Planning & Zoning Board Public Hearing

March 3, 2020 at 6:00 p.m.

Planning & Zoning Board Staff Report for March 3, 2020 Meeting

[SPR #20-02. Request of Tipu Keen for: Approval to construct a 634-square foot addition to the one-story, single-family home located at 2122 Lake Drive on Lake Killarney, zoned R-1A.](#)

NORMAL HIGH WATER ELEVATION ANALYSIS

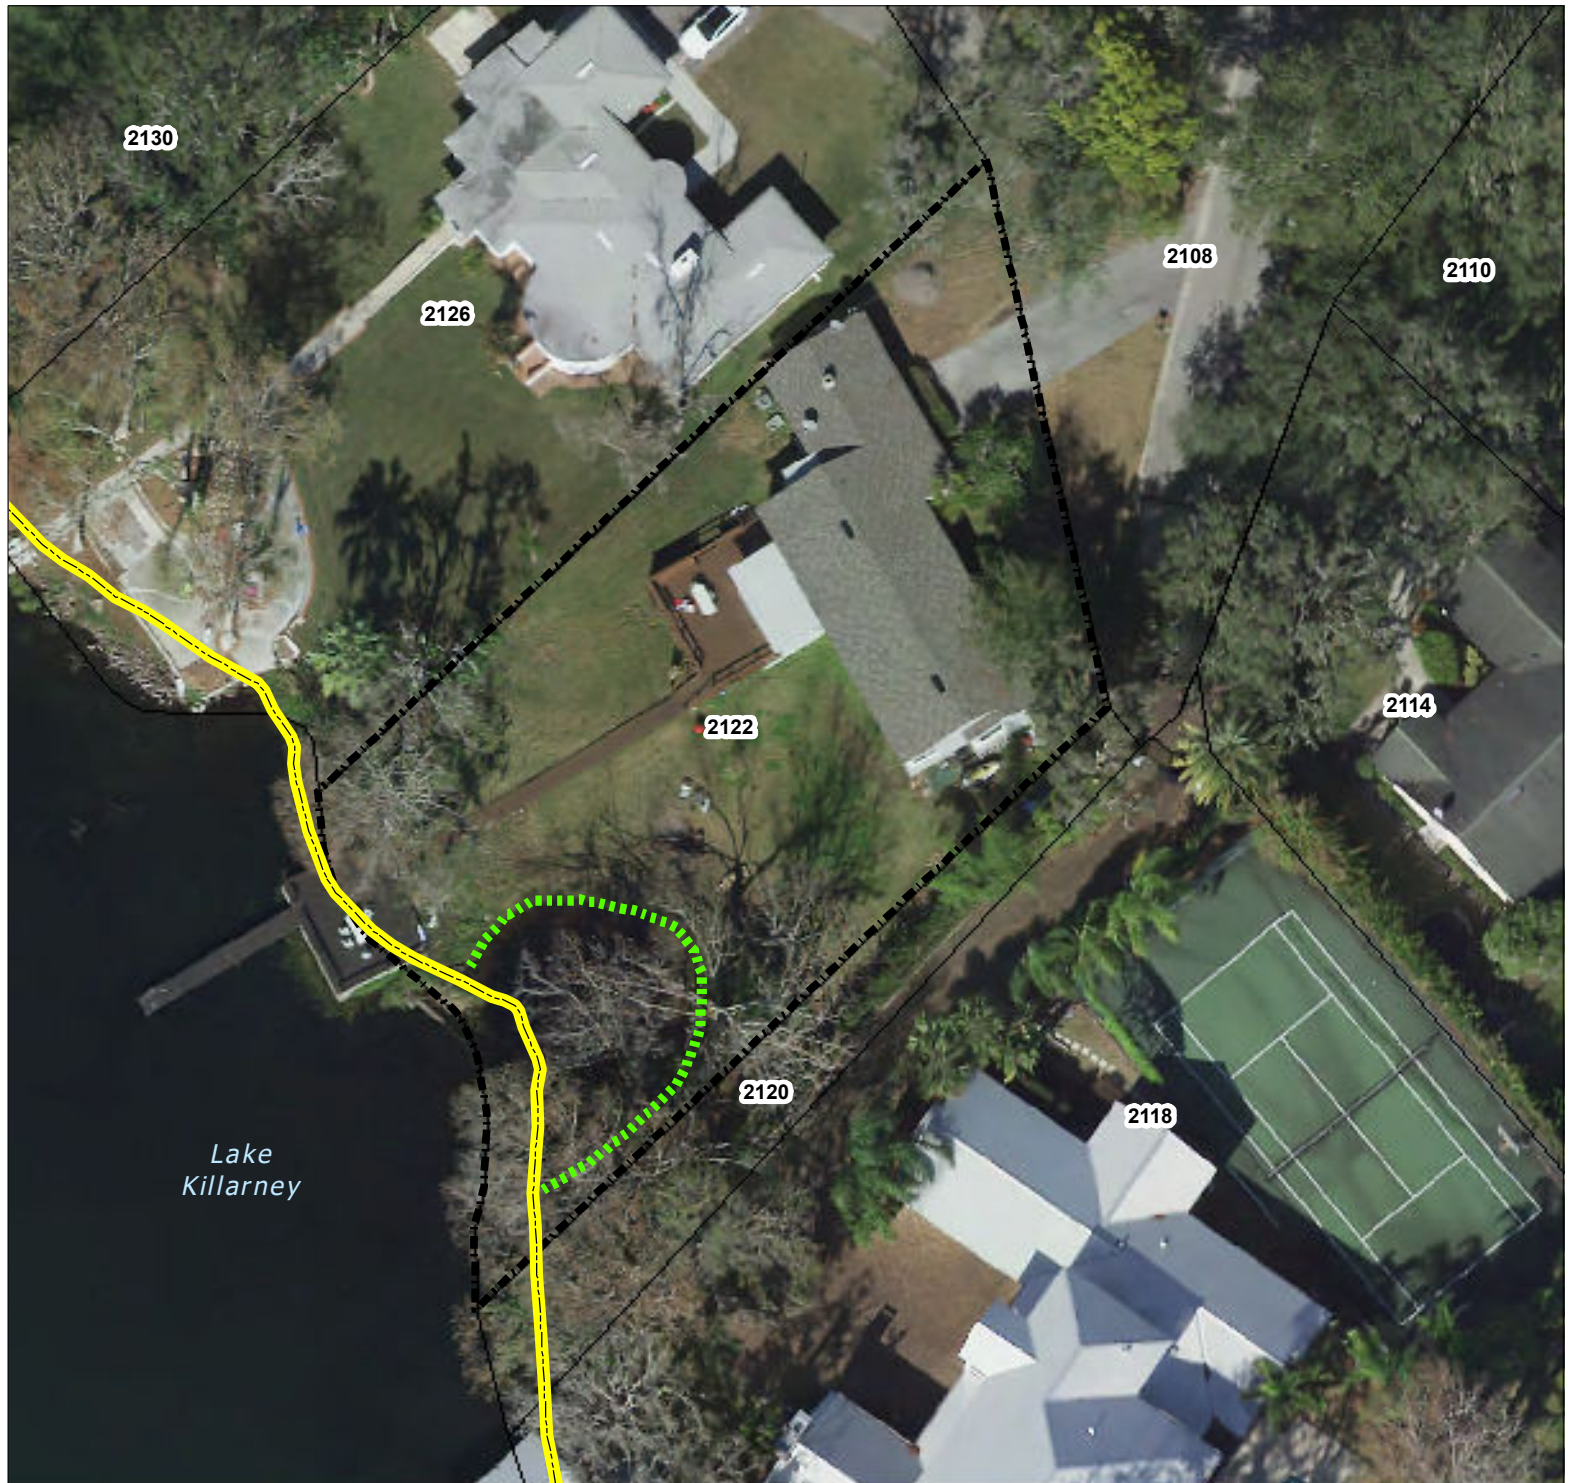
This property is unique in the fact that a previous owner dug out a portion of the land on the upland side of existing seawall to create a cove. Therefore, when the property was recently surveyed to determine the ordinary high water elevation (82 feet as defined in our code) for Lake Killarney, this elevation is now located further into the property (see attached survey for reference). Since the average lakefront setbacks are determined from this ordinary high water elevation, this cove affects the location of the setback measurements. Staff has determined that the average lakefront setback to be 60 feet, and as shown on the attached site plan, the applicant is proposing a 50-foot setback to the home addition from the ordinary high water elevation (as measured from the edge of the cove). However, if measured from the original ordinary high water elevation (see attached map for reference) the applicant would be exceeding this average. Therefore, P&Z has the authority to make the judgement call whether "lake views are being unduly impaired" with the setbacks as presented. It appears to staff that the proposed setbacks meet the intent of the code.

1 CONCEPTUAL SITE PLAN
C201 SCALE: 1" = 10'

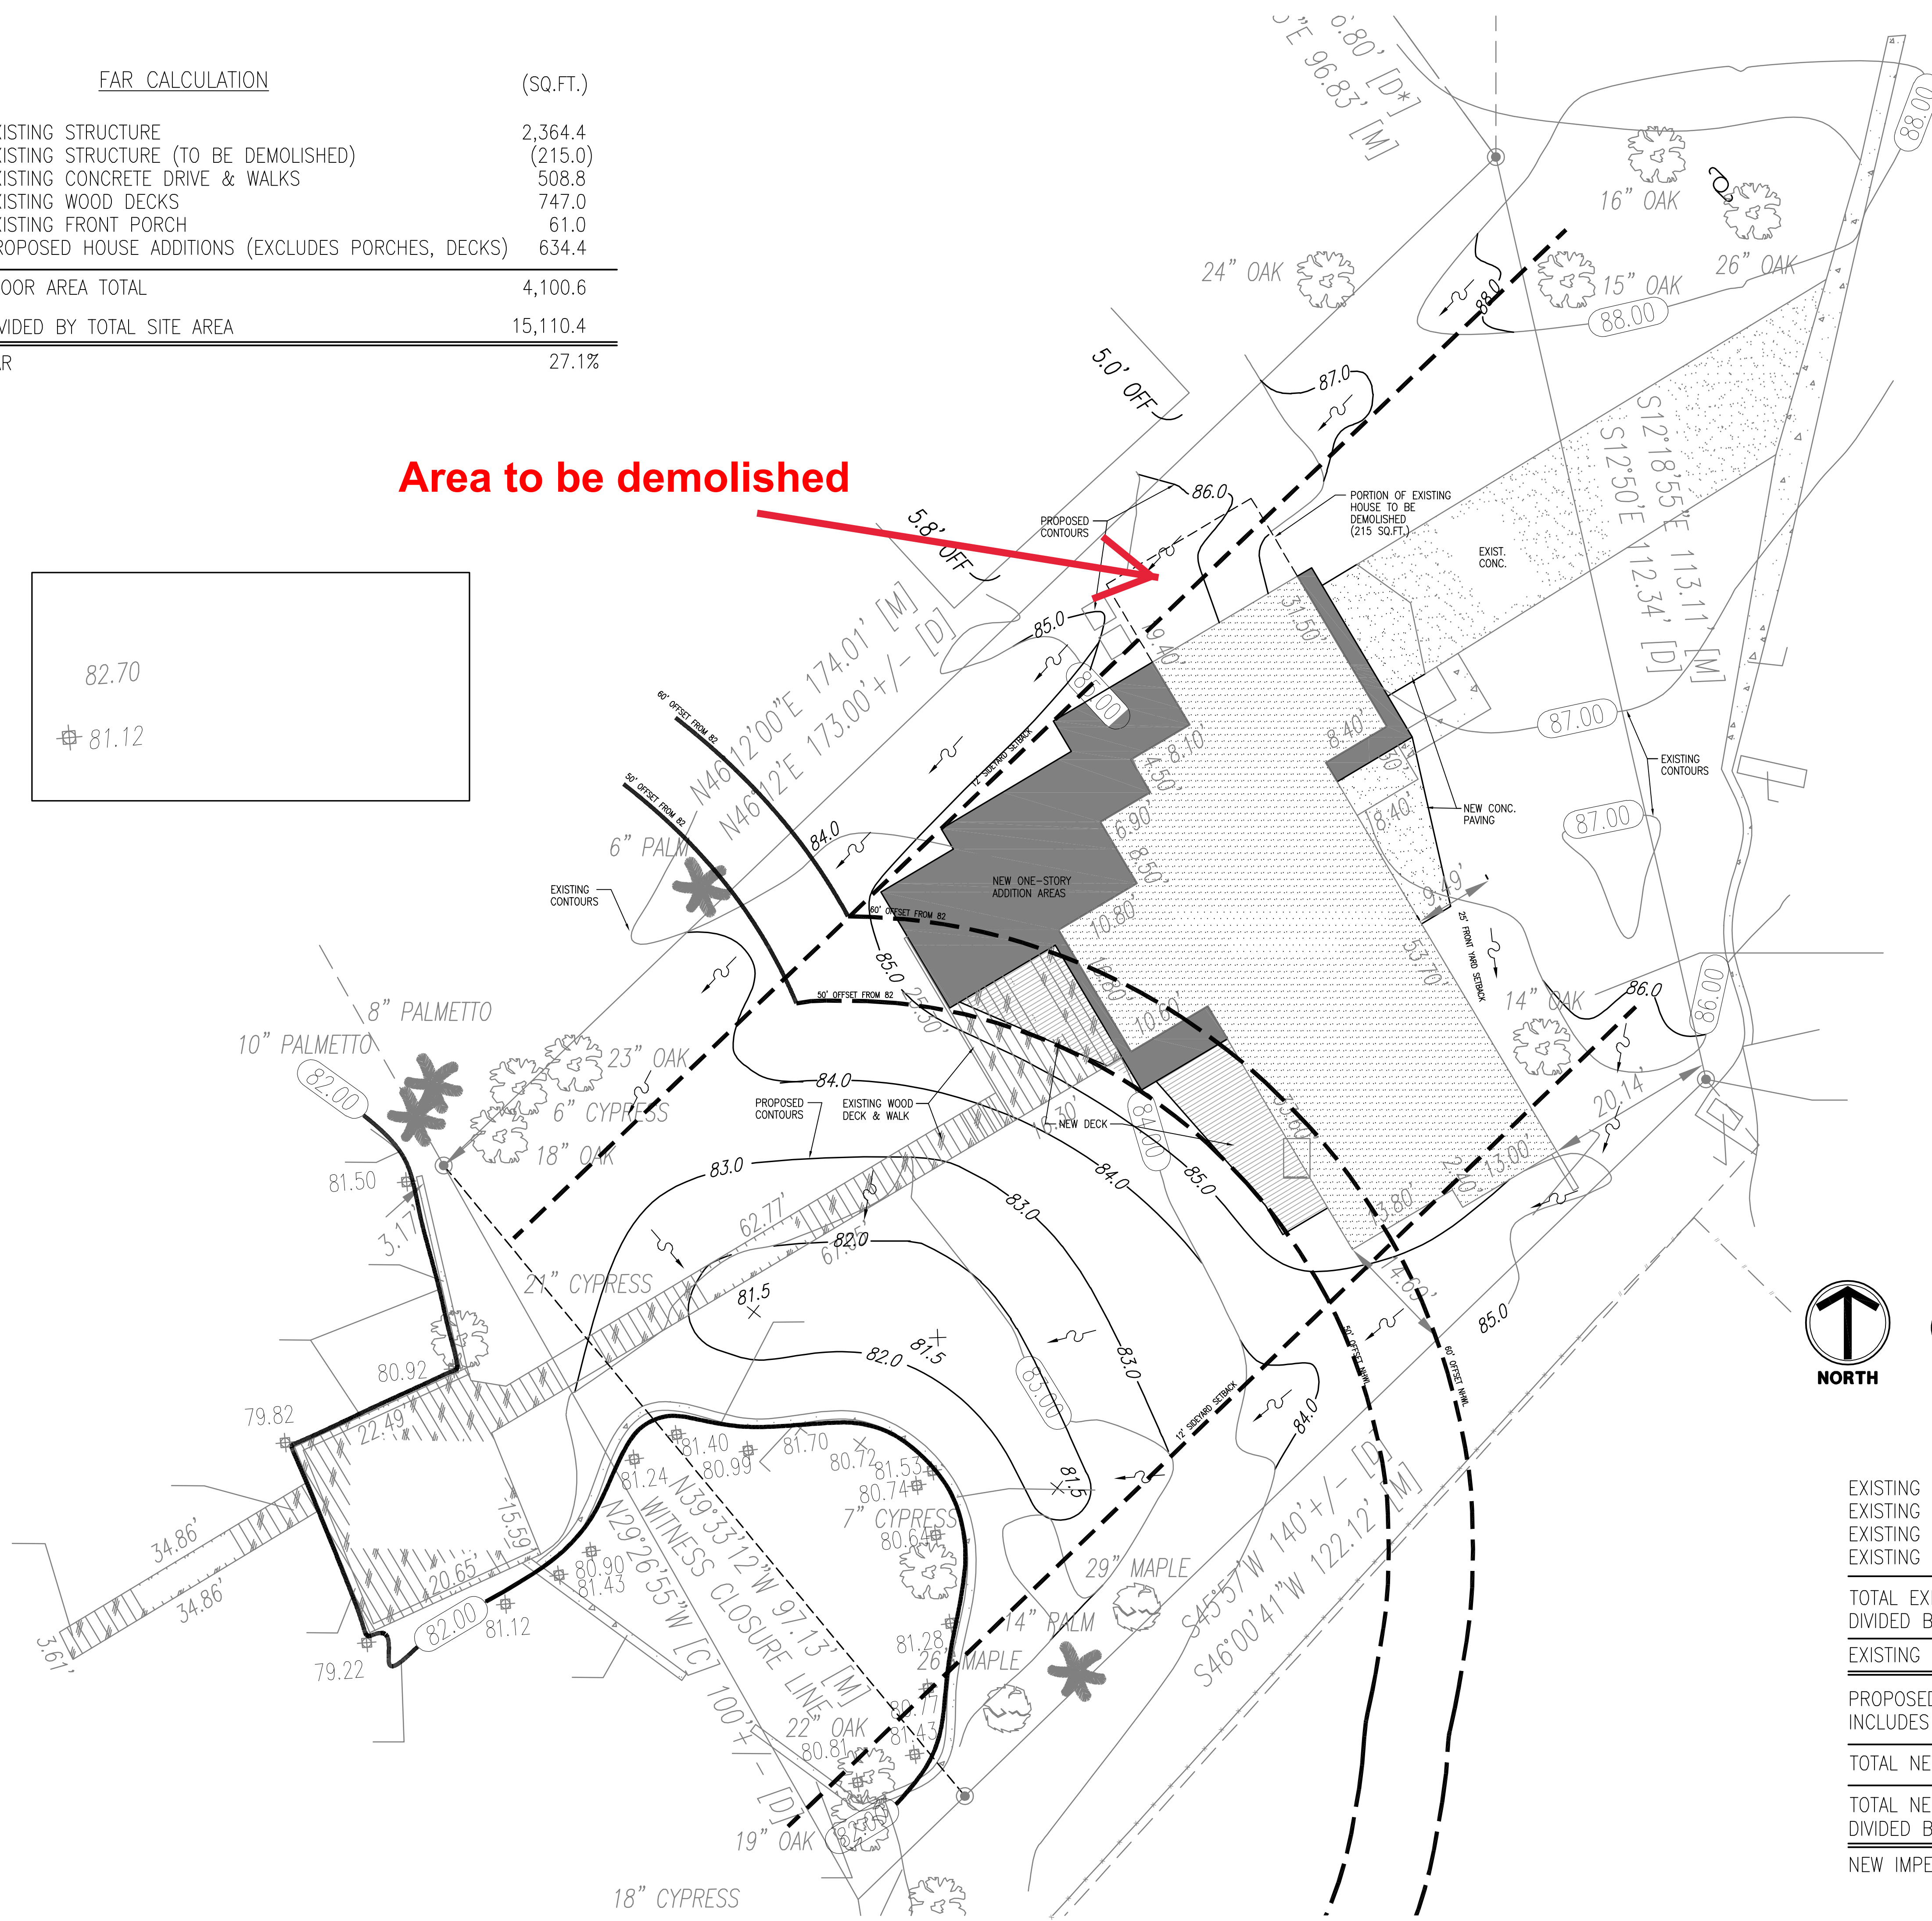
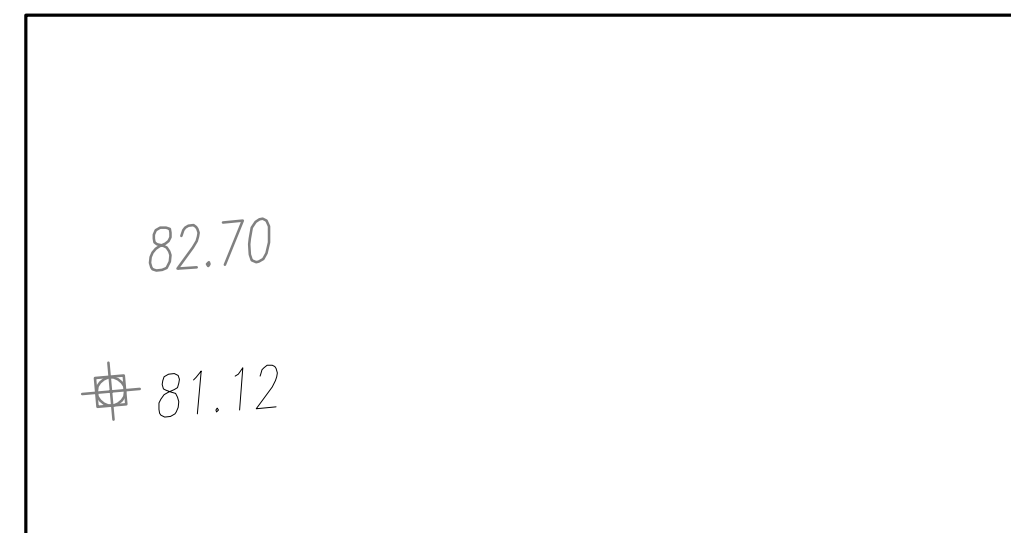
Tipu Keen (property owner) is requesting site plan approval to construct a 634-square foot addition to the one-story, single-family home at 2122 Lake Drive on Lake Maitland, zoned R-1A. The applicant is also demolishing 215 square feet of the western existing portion of the home. This property measures 15,110 square feet. Below is a table summarizing this request in comparison to the R-1A/lakefront lot requirements.

The code limits walls and swimming pool decks facing the lake in excess of three feet in height. Since this lot is relatively flat, there are no grade-drop issues throughout the length of this lot and the applicant is proposing to add onto the existing deck, and will meet the deck height code requirements.

The code requires retention of storm water so that storm water flowing over a lakefront lawn area does not carry with it into the lake any fertilizers, herbicides, or other chemicals that affect the water quality of our community's most precious assets. The amount of impervious surface on the lot determines the depth/size of the retention needed. The applicant is proposing a storm water swale near the lakefront that is sized to meet the city's code requirements. The impervious coverage is 35% versus the permitted 50%.

Staff recommendation is for approval.
